Proposal for amendments to ECE/TRANS/WP.29/GRPE/2016/3 (gtr 15 - WLTP)

Submitted by the experts from OICA and the Informal Working Group on Worldwide harmonized Light vehicles Test Procedure (WLTP)

This document is a proposal to amend and complete the GRPE working document ECE/TRANS/WP.29/GRPE/2016/3, submitted by the Informal Working Group on Worldwide harmonised Light vehicles Test Procedure (WLTP).

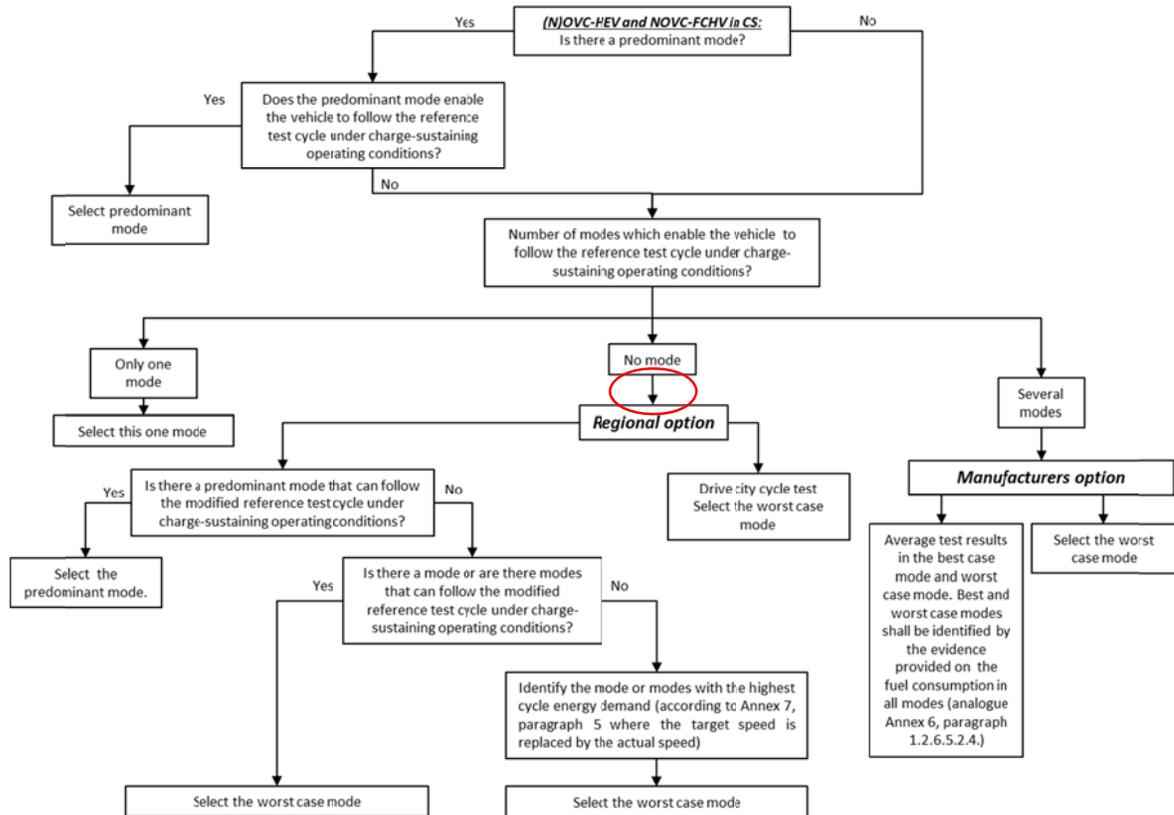
In Figure A8.App6/2 insert an arrow from the box “No mode” to the box “Regional option” as shown:
